## Application for Works Approval

**Works Approval Number** W6775/2023/1

**Applicant** Department of Communities

**Premises** Yungngora Wastewater Treatment Plant  
Legal description –  
Part of Lot 255 on Deposited Plan 220190  
Crown Lease PL N-049848  
As defined by the coordinates in Schedule 2 of the works approval

**Figure 1: Long-term water balance model for the new WWTP**

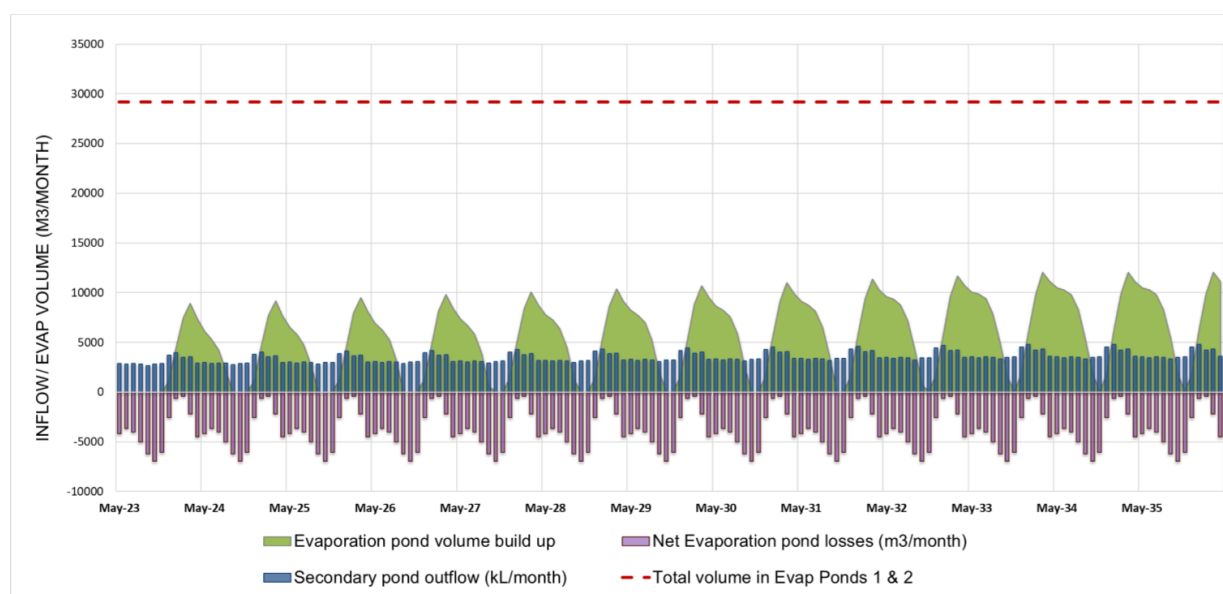
3. The sizing of the ponds need to be based on the prescribed volumes as per <i>Health (Treatment of Sewage and Disposal of Effluent and Liquid Wastes) Regulations, 1974</i> , and Supplement to Regulation 29 and Schedule 9 - Wastewater system loading rates (health.wa.gov.au);	The application documents indicate that the primary and secondary ponds meet the dimensions for a waste stabilisation pond listed in r.50(1)(f) of the Health (Treatment of Sewage and Disposal of Effluent and Liquid Wastes) Regulations 1974. Other volume measurements do not seem to apply to this system.  A long-term water balance was provided that shows the WWTP ponds are adequately sized to accommodate the wastewater from the townsite.
